**PREFERRED PROJECT REPORT FOR CONCEPT PLAN APPLICATION-
RESIDENTIAL DEVELOPMENT AT 74-76 BELMORE STREET, RYDE
(MP10_0110)**

**Preferred Project Report for Concept Plan Application – Residential Development at 74-76
Belmore Street, Ryde (MP10_0110)**

**PROJECT REPORT
74-76 BELMORE STREET, RYDE**

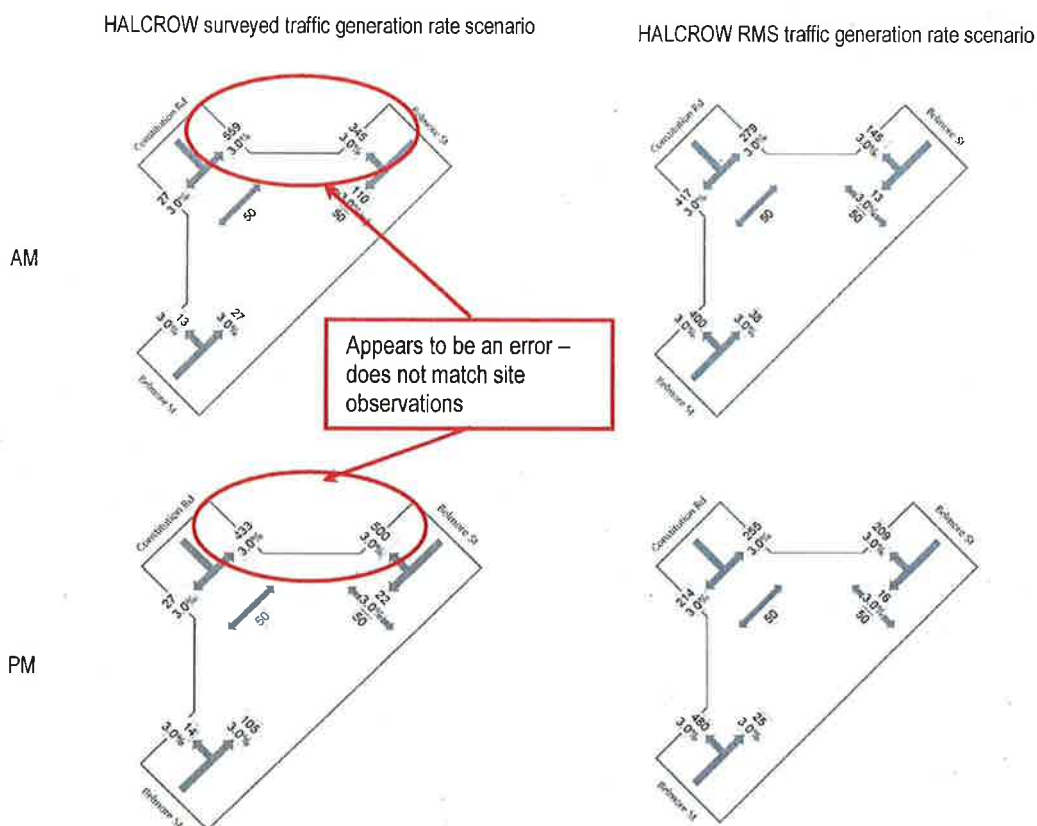
- The reasoning provided by Halcrow for the use of the reduced traffic generation rates derived from survey data in their initial report appear sound (i.e. based on surveyed developments), however no details were provided of the surveyed developments in terms of their size or specific location.
- The model results tabulated in Table 2-4 and Table 2-5 appear to have some inconsistencies with the results contained within the SIDRA models themselves.

The intersection was run as vehicle actuated in the PM peak hour for the surveyed traffic generation rate scenario which is inconsistent with the other model runs for the intersection which ran it with a fixed cycle time of 90 seconds.

It is known anecdotally that motorists use Constitution Road and Belmore Street to gain access to/from the M3 to the south of the development hence, there is expected to be a high right turn volume into Belmore Street (south) from Constitution Road in the AM peak and a high left turn volume from Belmore Street (south) into Constitution Road in the PM peak. This is reflected in the volumes for the RMS traffic generation rate scenario but not for the surveyed traffic generation rate scenario as shown in Figure 2.1. These volumes have been extracted from the SIDRA files provided with the exhibition materials.

The reasoning for the inconsistency in the turning movement volumes used for the analysis of this intersection is not explained in the *Supplementary Traffic Modelling Analysis Report*. Moreover, based on our local knowledge and counts undertaken in the area, the volumes in the “surveyed traffic generation scenario” do not appear to be correct. However, the volumes used in the most recent round of analysis under the RMS traffic generation rate scenario better reflect observed conditions on-site and are acceptable.

Accordingly the preferred mitigation measure at this intersection is the extension of the right turn pocket in Belmore Street by 45m to 90m.

Council requests that any approval of the concept plan should be conditioned to extend the right turn pocket for turns from Belmore Street into Constitution Road to a length of 90m, and all road works and intersection improvement works should be carried out at no cost to Council and the RMS.
